HISTORIC PRESERVATION COMMISSION STAFF REPORT

APPLICATION: CA2017-01

TITLE: Certificate of Appropriateness CA2017-01;
HL-107/MA-101

REQUEST: Review the exterior renovations on a single-family Craftsman residence which includes new wood shingles and clapboard siding, replacement of window and door surrounds, repair of overhanging eaves, rafter tails and gabled front porch roof. Review the exterior remodel of the rear (north) building elevation.

EXISTING REAR ELEVATION

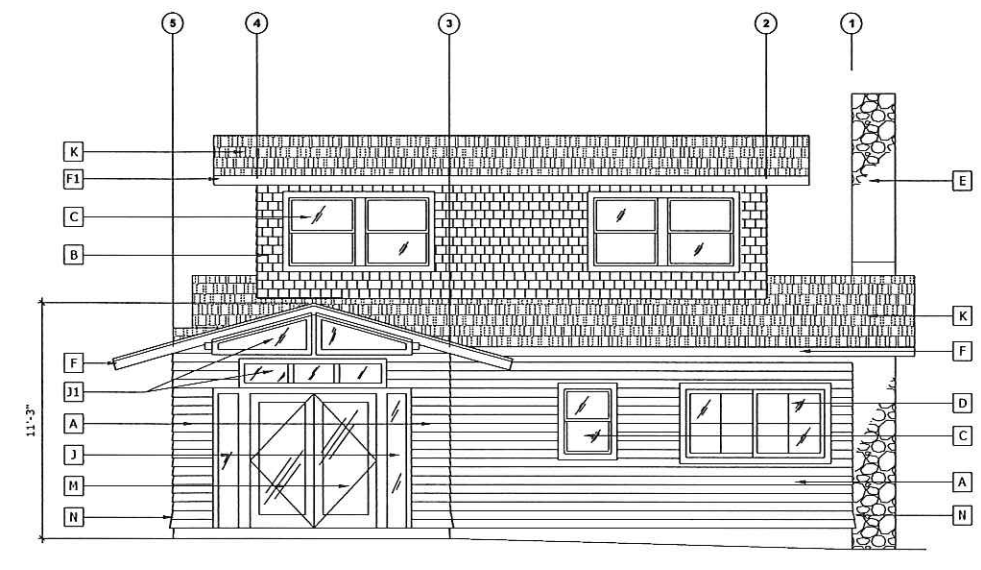
The north (rear) elevation is where “in kind” repair and replacement work has evolved to a complete exterior “remodel.” An original single rear door was removed and a larger single-paned double door with side lights was installed in its place. Above the double door the property owner chose a more modern application and installed five fixed windows to allow light into the kitchen area which now has a vaulted ceiling. The one side window on the west

The rear (north) building elevation changes are not of a Craftsman architectural design, and therefore do not satisfy the criteria for issuing a Certificate of Appropriateness. It is a remodeled elevation with a modern design application and cannot be considered a restoration. For this reason, staff recommends that the remodel not be part of this Certificate of Appropriateness (CA2017-01) application and instead an ad hoc subcommittee of two members be appointed to assist both City staff and the property owner on reaching an appropriate improvement plan for the rear elevation. Any recommendations of the subcommittee along with a revised elevation proposal from the property owners would be brought back to the Historic Preservation Commission for review and final approval of a separate Certificate of Appropriateness specific only to the remodel.

RECOMMENDATION: Staff's determination is that the scope of work completed on the property, with the exception of the window and door improvements made to the rear elevation, meets the findings for a Certificate of Appropriateness. For this reason staff recommends approval of all in-kind restoration work and that the Historic Preservation Commission approve the formation of a two member subcommittee to assist and guide the property owners with an alternative design for the rear elevation. If the Historic Preservation Commission concurs then the appropriate motions are:
